CA-SOP-IR-1

Ref: HECO, HELCO, and MECO Preliminary SOP, Exhibit A. Page 1, issue 1, paragraph 1, lines 5 through 9.

HECO Response:

FIGURE 6-4: UTILITY-SPONSORED CHP TO MAINTAIN CONTINUOUS RATING ON 7300 LINE WITH 7200 LINE OUT-OF-SERVICE

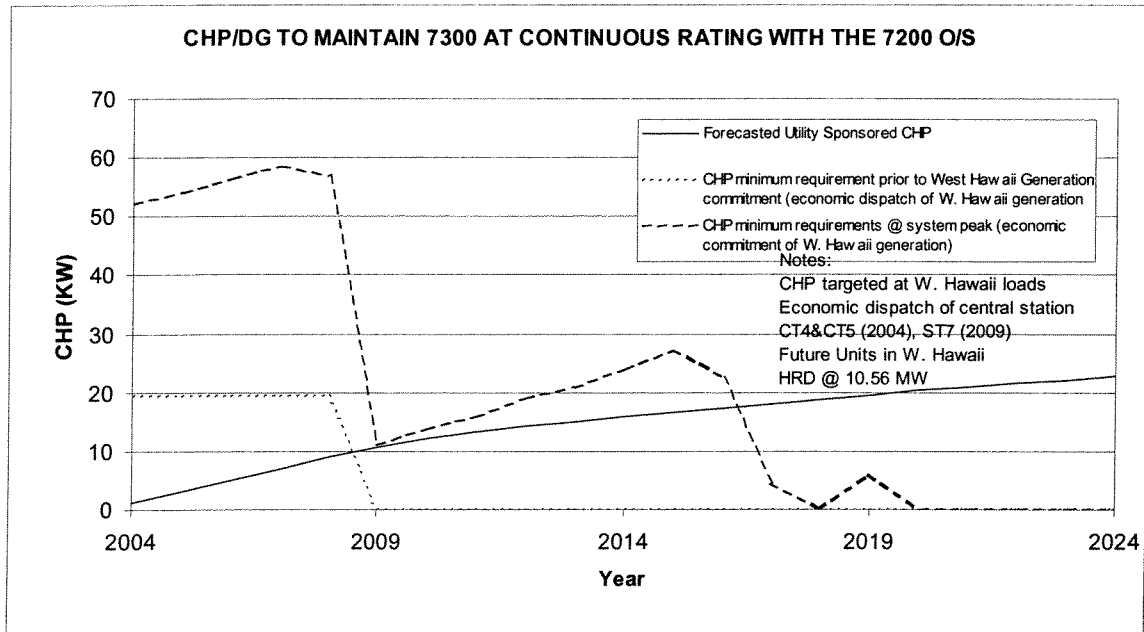
- a. Please discuss whether each of companies have a similar study evaluated the opportunities and analyzed the feasibility for distributed energy resources of more recent vintage. If so, please provide a copy of those studies.
- b. If not specifically discussed, in any studies provided in response to part a. above, please discuss whether there are any circumstances that currently exist where DG could be effectively used on distribution circuits? Please provide copies of maps that show distribution circuits and locations that DG could be sited effectively and the studies or analyses that support the response.

utility-sponsored CHP, the situation is slightly different because the utility-sponsored CHP will be committed before Keahole and therefore the utility-sponsored CHP will raise the load level before which Keahole generation comes on-line, in a similar fashion to the situation with as-available generation or the HCPC contract. In order to define an upper limit to the amount of utility-sponsored CHP that will be required to back-off the overload on the 7300 line with the 7200 line out-of-service, the analysis looked at peak conditions with utility-sponsored CHP installed. Load flow studies determined that the amount of utility-sponsored CHP required to reduce the overload on the 7300 line with the 7200 line out-of-service will increase from about 52 MW in the year 2004 to about 59 MW by the year 2007. Under the assumption that the ST-7 unit comes on-line in the year 2009, the amount of utility-sponsored CHP required to reduce the overload on the 7300 line will drop to about 10 MW. The large dashed line on Figure 6-1 shows the upper bound of the amount of utility-sponsored CHP required to maintain the continuous rating on the 7300 line with the 7200 line out-of-service. For this analysis, west Hawaii is assumed to be the next generating plant after ST-7 is installed at Keahole with the first CT starting in the year 2017. The solid line shows the projected amount of utility-sponsored CHP based on HELCO's forecast.

One important result from this analysis is that there will not be sufficient utility-sponsored CHP early enough in time to reduce the overload on the 7300 line as a result of a 7200-line contingency based on current conditions. In addition, since only approximately 23 MW of utility-sponsored CHP is forecast by the year 2024, the projected amount of utility-sponsored CHP will not match the peak load utility-sponsored CHP requirement until the year 2016. At about \$1,000/kW, the 20 MW of utility-sponsored CHP will cost approximately \$21 million (2004 \$), which is about 5 times the cost of reconductoring the two lines 69 kV lines depending on which of the two conductors is selected. At the high end of the required utility-sponsored CHP, 59 MW will cost about \$61 million, which is about 13 times the cost of the reconductoring. Therefore, the installation of utility-sponsored CHP as an option to maintain the continuous rating on the 7300 line will cost between \$21 and \$61 million. There has been no utility-sponsored CHP installed to date because the program is still under consideration by the PUC. Similarly, the foregoing analysis assumes economic generation commitment conditions. Detailed calculations showing the cost of the utility-sponsored CHP for this option are shown in Tables E-2 and E-3 of Appendix E.
